Subject: PWR Owners Group, Risk Management Committee  
PWR Owners Group Transmittal of the PWROG Comments on  
NUREG-2195, "Consequential SGTR Analysis for Westinghouse and  
Combustion Engineering Plants with Thermally Treated Alloy 600 and 690  
Steam Generator Tubes," per PA-RMSC-1292

### Comments on the Draft Report for Comment Version of NUREG-2195, "Consequential SGTR Analysis for Westinghouse and Combustion Engineering Plants with Thermally Treated Alloy 600 and 690 Steam Generator Tubes"

Figure A-1 Comparison of MELCOR predictions with CCNPP PCTRAN Analytical Predictions (Early onset SBO)

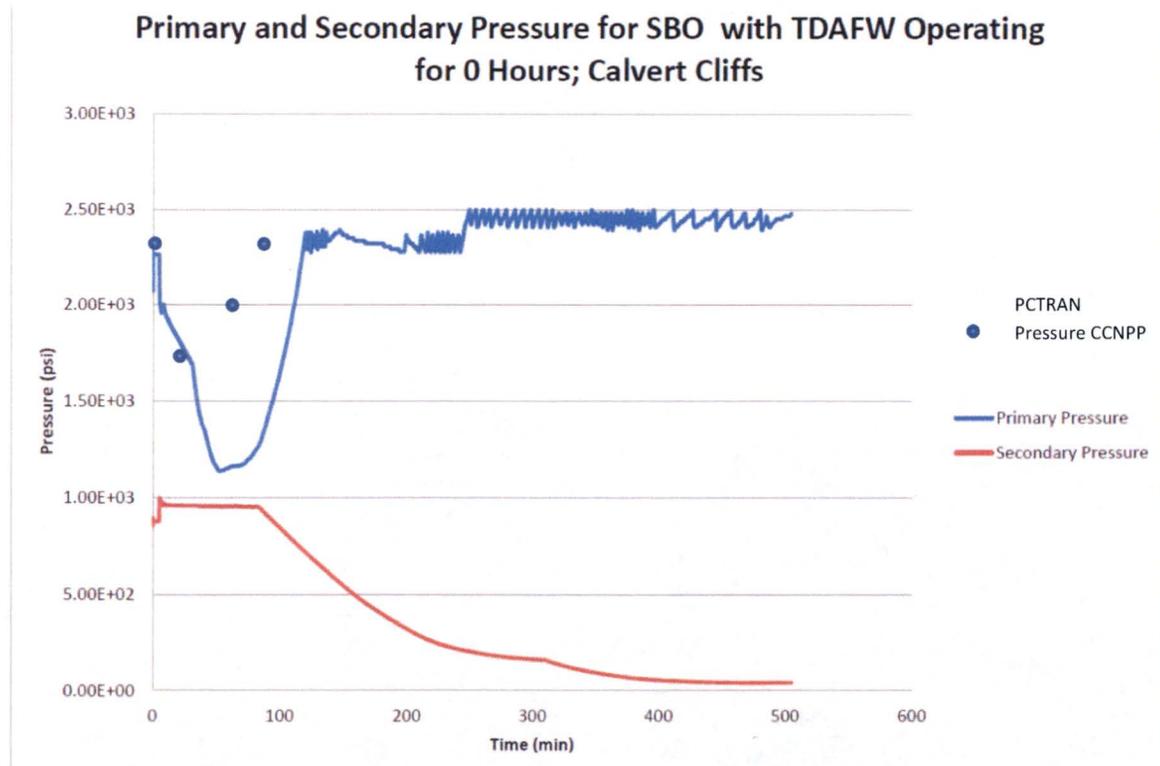
This leakage value is not typical of CE PWRs. With controlled bleed-off (CBO) not isolated, leakage rates would be on the order of 2 gpm. If CBO is isolated, the leakage would be lower. The increased leakage results in more rapid depressurization of the RCS.

(In order to estimate the potential impact of the thermal hydraulic assumptions, Calvert Cliffs SBO results using the PCTTRAN code was reviewed and compared with the early pre-core uncover predictions from MELCOR. RCS pressure differences are illustrated in Figure A-1 and Figure A-2. Both cases suggest that the 21 gpm /pump assumed RCP leak rate resulted in a high system depressurization. The impact on core uncover was assessed for early and delayed SBO. MELCOR prediction estimated early and delayed SBO core uncover times of about 210 minutes and 450 minutes, respectively. The corresponding PCTTRAN predictions are

270 minutes and 600 minutes, i.e., the core uncover transient appears to be accelerated in the MELCOR model.)
